Project	IEEE 802.16 Broadband Wireless Access Working Group < http://ieee802.org/16 >	
Title	Changes to clause “Network - based identification of specific spectrum services”	
Date Submitted	2008-05-05	
Source(s)	Mariana Goldhamer Alvarion Ltd. 21A, Ha Barzel Street, Tel Aviv, Israel	E-mail: mariana.goldhamer@alvarion.com
Re:	LB 29	
Abstract	The document is a proposal for profiles based on the poll taken in November 2007 meeting, in relation with comment 092 in database IEEE 802.16/07-53r2	
Purpose	[Description of what <i>specific</i> action is requested of the 802.16 Working Group or subgroup.]	
Notice	<i>This document does not represent the agreed views of the IEEE 802.16 Working Group or any of its subgroups. It represents only the views of the participants listed in the “Source(s)” field above. It is offered as a basis for discussion. It is not binding on the contributor(s), who reserve(s) the right to add, amend or withdraw material contained herein.</i>

Changes to clause “Network - based identification of specific spectrum services”

In response to comments addressing the existence of the IP messages in the 802.16h Draft P802.16h/D4, are needed also a number of changes to the

Figure h65—Architecture for coexistence of BWA and preferred radio applications

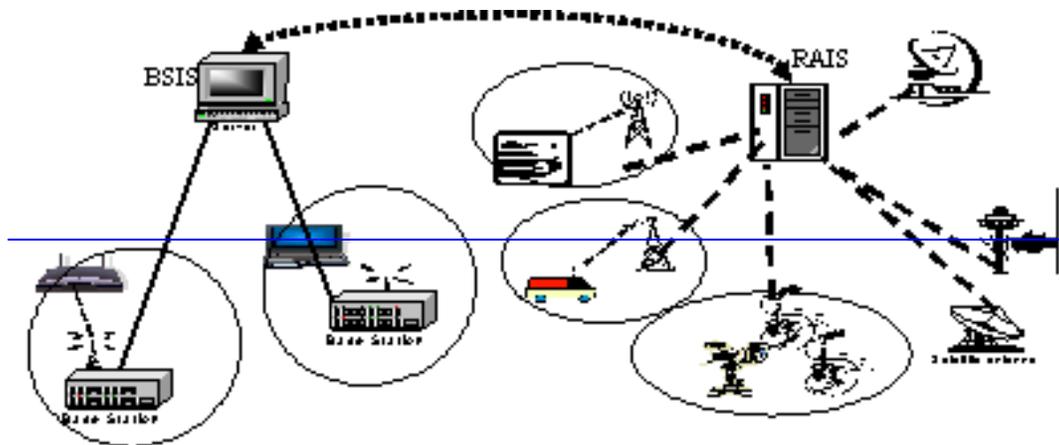
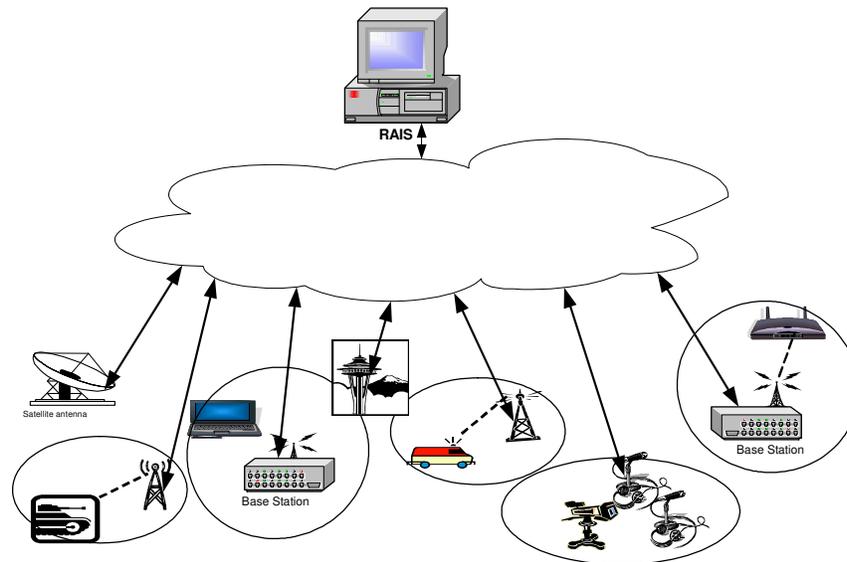
The proposed architecture uses ~~different servers for the BWA systems and the systems to be protected, namely the BSIS (Base Station Identification Server) for the BWA systems and~~ the RAIS (Radio Application Identification Server) for the devices providing specific radio applications. Generally the ~~BSIS will be maintained by a Service Provider and the~~ RAIS will be provided by the National Radio Administration. The communication of the BS with ~~the BSIS or of the specific radio devices with~~ the RAIS is secured by VPN or other procedures.

Architecture for coexistence of BWA and preferred radio applications Figure h-65 gives an example of the proposed architecture. The BSIS are connected to the Base Stations providing BWA services. The RAIS has connections with the BWA Base Stations, but also with Base Stations providing TV applications, Satellite applications, Military applications, Health applications, Security applications, etc. ~~In all these cases secure communication shall be established between the RAIS and the Base Stations or the Service Providers providing these services.~~
